PROPOSED HINCKLEY RAIL INTERCHANGE ACCESS ROAD

M69 JUNCTION 2 / B4668, HINCKLEY

STAGE 1 ROAD SAFETY AUDIT

REPORT REF: 24-1363.01-RSA1C

M69 Junction 2 / B4668 Roundabout Terminal Junctions

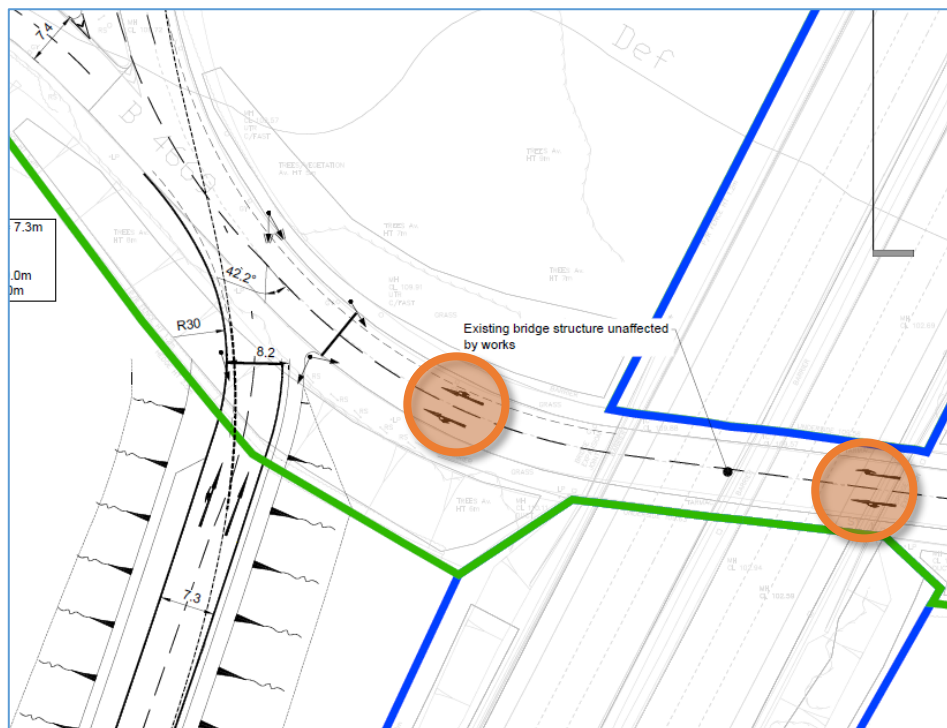
3.2. **Problem 1**

Location: M69 J2 southern circulatory carriageway.

Summary: Confusing road markings risk side swipe type collisions.

Around the southern carriageway of the circulatory the lane destinations show an “ahead” and a “right turn” arrow. However, approaching the junction and on the approaches before this point, “ahead” and “ahead and right” arrows are shown. This could lead to late lane changes, sudden and unexpected braking and side swipe type collisions due to driver confusion and late decision making as a result of confusing and misleading lane destinations.

3.3. Problem 2

Location: M69 southbound approach to the new signalised junction.

Summary: Poor forward visibility of signals risks late braking and junction overshoot type collisions.

The southbound off-slip approach to the proposed signals at Junction 2 has a significant vertical and horizontal alignment change on the approach to the current Give-Way line. There is a concern that, given these changes and the existing signing infrastructure, that forward visibility towards the signal heads will not be provided for vehicles.

3.4. **Problem 3**

Location: M69 southbound approach to the new signalised junction.

Summary: Amended stop line position risks loss of control type collisions and shunts.

The provision of the stop line at the signalised off-slip means that the existing high friction surfacing will be substandard in length. This could lead to loss of control collisions or shunts involving late breaking vehicles.

3.5. **Problem 4**

Location: M69 southbound approach to the junction.

Summary: Amended signing missing diversion information risks late manoeuvres and shunts / side swipe collisions.

Whilst it is appreciated that the sign design is at a preliminary stage, the proposed signing eliminates / does not include the existing diversion route symbol. This could result in confusion for drivers following the diversion route, resulting in late lane changes and shunt type collisions.

It is recommended that the markings are amended so that they are consistent with the available movements around the southern half of the circulatory and on the westbound link road exit.

It is recommended that the signals are located and designed, including raised poles and/or gantry signals if needed, so as to provide adequate forward visibility for approaching vehicles. Furthermore, it is recommended that the signing on the approach is amended so as not to pose an obstruction.

It is recommended that, as part of the detailed design, the length of high friction surfacing is amended to consider the amended stop line position.

It is recommended that, as part of the detailed design, the diversion route symbols are included where appropriate.

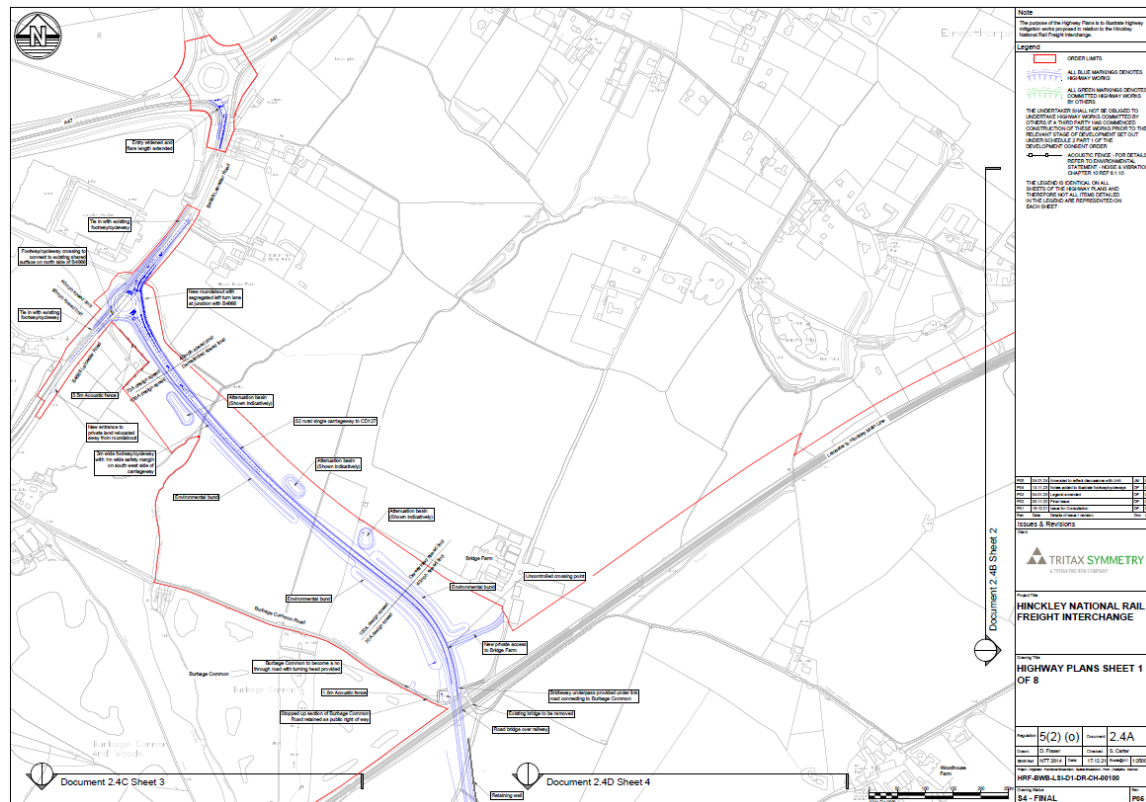
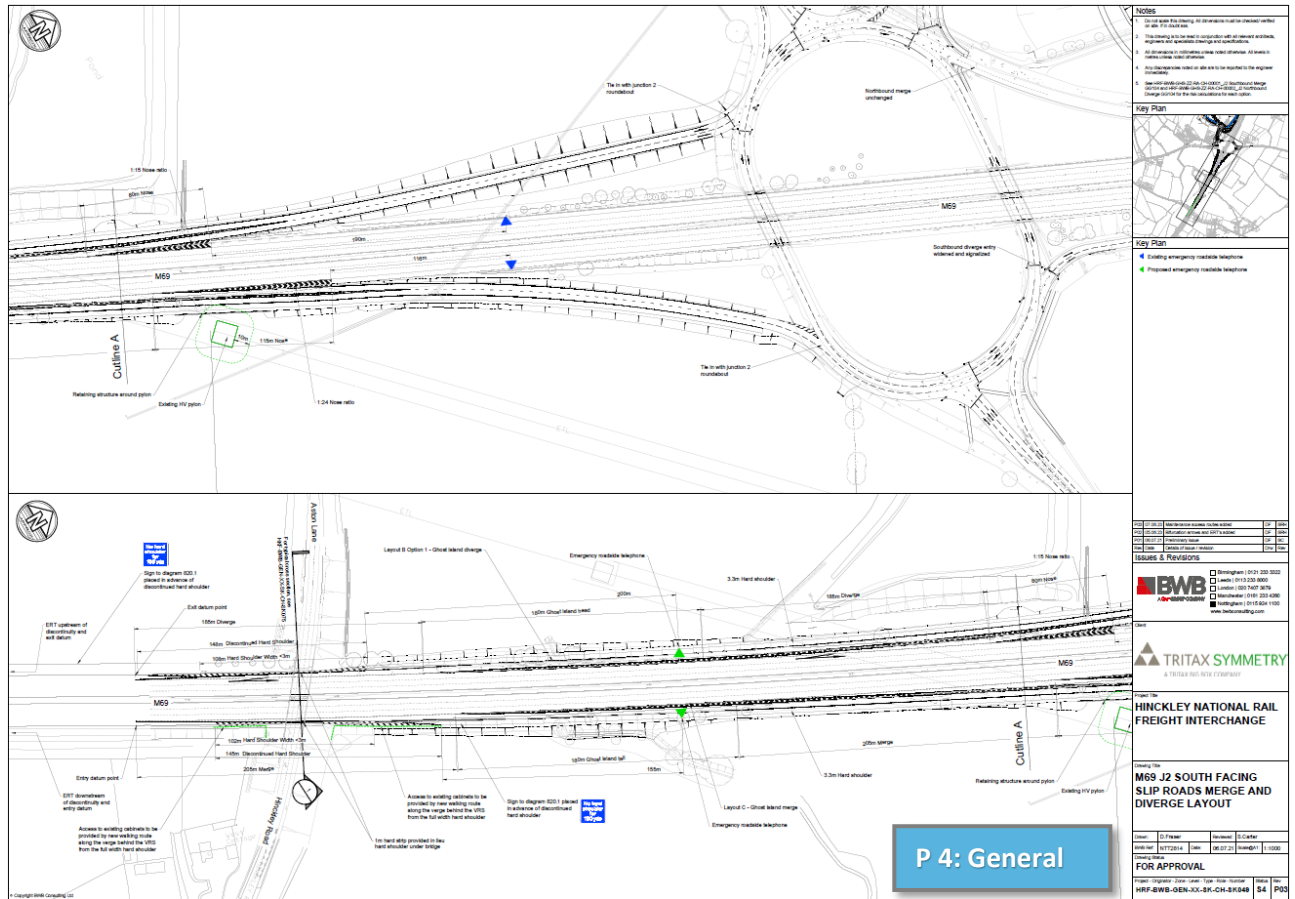
Between J2 on the M69 and the first internal roundabout it is proposed to install a Pegasus crossing. The crossing is shown as a single stage crossing for all users, with the roundabout to the north shown as only a two-arm junction at this time. The crossing is approximately 18m in length - as part of the detailed design it should be ensured that the crossing timings and on-crossing detection account for slow moving equestrians, especially as the central splitter island is not of sufficient width for equestrian or cyclists to safely wait.
